## Preferred Project Report

### Sir Moses Montefiore Jewish Home

100 - 120 King Street and 30 - 36 Dangar Street, Randwick

Submitted to  
Department of Planning  
On Behalf of Sir Moses Montefiore Jewish Home

**Figure 2** – Detailed section showing the amenity of the public plaza and colonnade

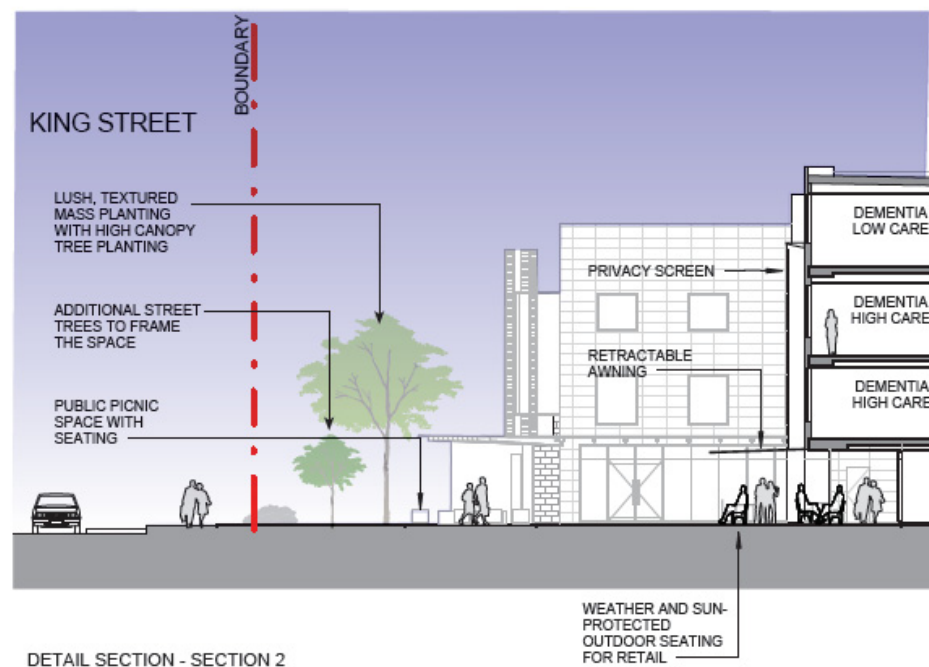
Whilst the proponent has considered the Department's submission and its concerns regarding the amenity and useability of the space, no changes are proposed to the colonnade area fronting the public plaza at King Street. It is considered that the colonnade will provide for a high level of amenity, and contrary to the views of the Department, will make a positive contribution to the useability of the public space.

The merits of the colonnade are set out below, and are illustrated graphically at **Figure 2** - see also the architectural plan set at **Appendix B**. The proposed colonnade with a depth of 4m will provide:

In summary, a narrower colonnade would be less functional, and would not facilitate multiple uses. Replacement of the colonnade with a fixed awning would create a space that is more exposed, and would also negate the ability to use an extendable awning that will increase amenity and the outdoor seating capacity at the edge of the public space.

If Building D were to be setback to reduce the extent of the 'overhang', this would lead to a loss of high and low care dementia accommodation, and would compromise the efficiency of the Home, as well as the amenity of the internal courtyard. It would also reduce passive surveillance over the public plaza. If the retail space were brought forward to eliminate the colonnade, this would create approximately 110m<sup>2</sup> of additional retail space. This would lead to a non-compliance with Council's controls for the site, and would be in excess of what the site and surrounding area can support.

**Figure 7** – Setbacks between the Centennial and the revised Building / Envelope E

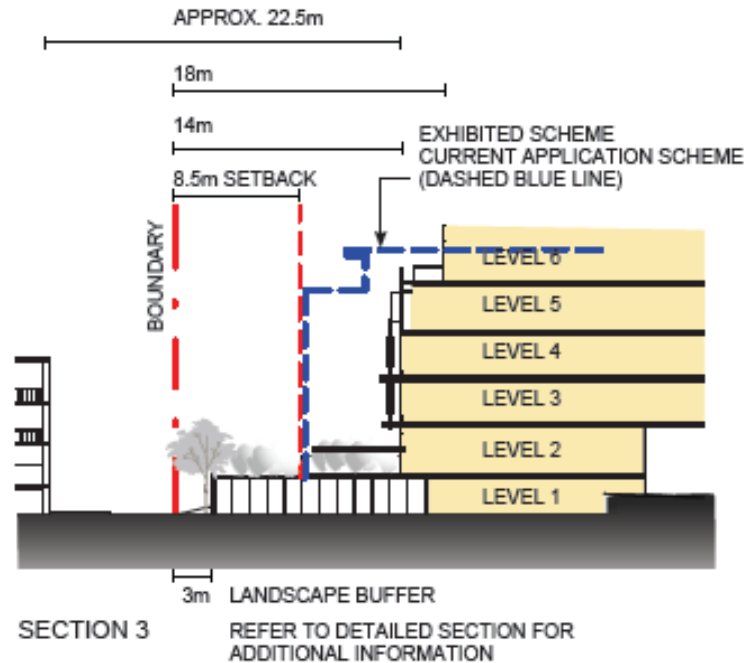
In order to address privacy impacts, and provide a more appropriate transitional element between the proposed development and the Centennial Apartments, Envelope F has been deleted, with much of Envelope F being incorporated into a revised Envelope E. The resulting setbacks are shown at **Figure 7**. The setback has increased to some 22.5m between the self-care residential levels and the Centennial Apartments, alleviating any privacy concerns. Further, the previous setback from the boundary of 8.5m has been increased to 14m to the substantive face of the building. The proposed setback is considered generous, exceeding Council's controls, which require a 5m side setback and the RFDC Rules-of-Thumb, which require an 18m separation distance between buildings of five to eight storeys. As discussed in Section 3, a number of additional mitigation measures are proposed to eliminate privacy concerns, including:

- provision of a 3m wide planted buffer zone between the western boundary and the relocated child care centre;
- the addition of a 'green roof' to the childcare centre, providing for an increased landscape screen edge to the high care and self care building above the childcare centre and reduced perception of a hard edge;
- replacing the balconies on the high care floors to generously proportioned non-accessible planter boxes;
- providing balustrades that are designed to limit views down, but still allow for horizontal views and light penetration for the proposed building; and
- windows that are screened from the western sun. The screens are designed to limit perpendicular views out and facilitate the southern and northern outlook.

This proposed separation distance is well in excess of the relevant controls and rules-of-thumb, and together with the measures listed above, will mitigate against any potential privacy impacts.
